Form C-103
 Revised July 18, 2013

WELL API NO. 30-025-31516	
5. Indicate Type of Lease STATE ☒ FEE ☐	
6. State Oil & Gas Lease No.	
7. Lease Name or Unit Agreement Name	
8. Well Number	98
9. OGRID Number 241333	
10. Pool name or Wildcat [40990] LOVINGTON, UPPER SAN ANDRES, WEST	
4. Well Location Unit Letter D : 100 feet from the NORTH line and 1305 feet from the WEST line Section 17S Township 36E Range NMPM County LEA	
11. Elevation (Show whether DR, RKB, RT, GR, etc.) 3900' GL

Please see attached procedure for well abandonment details

Operator: CHEVRON U S A INC 6301 Deauville Blvd Midland, TX 79706	OGRID: 4323
	Action Number: 61254
	Action Type: [C-103] NOI Plug & Abandon (C-103F)

PROPOSED Wellbore Diagram

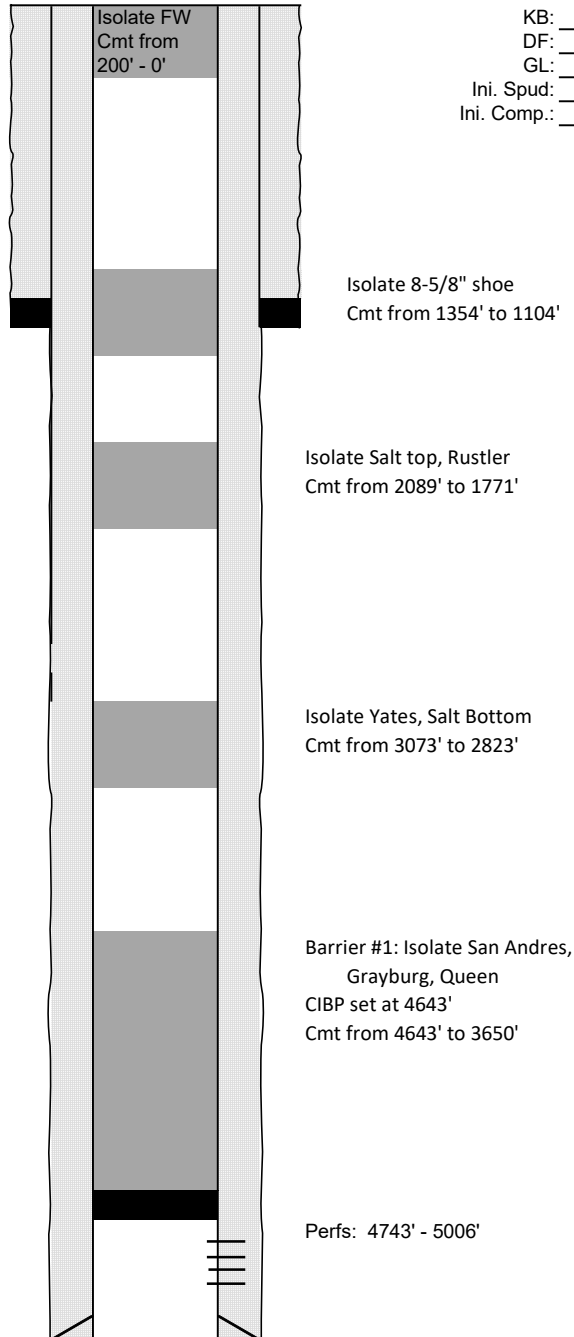
Note changes to procedure

20. Spot 32 sacks Class C cement from 2089' to 1771' (Top Salt, Rustler).
21. ~~Spot 25 sacks Class C cement from 1354' to 1104' (8-5/8" shoe).~~ **P&S 50 on XX**

22. ~~Spot 25 sacks Class C cement from 200' to surface (isolate Fresh Water zone at +/- 100')~~ **P&S 50 on XX**
23. While RDMO, perform 30-minute bubble test on surface and production casings. Record results to meet the barrier standard intent.
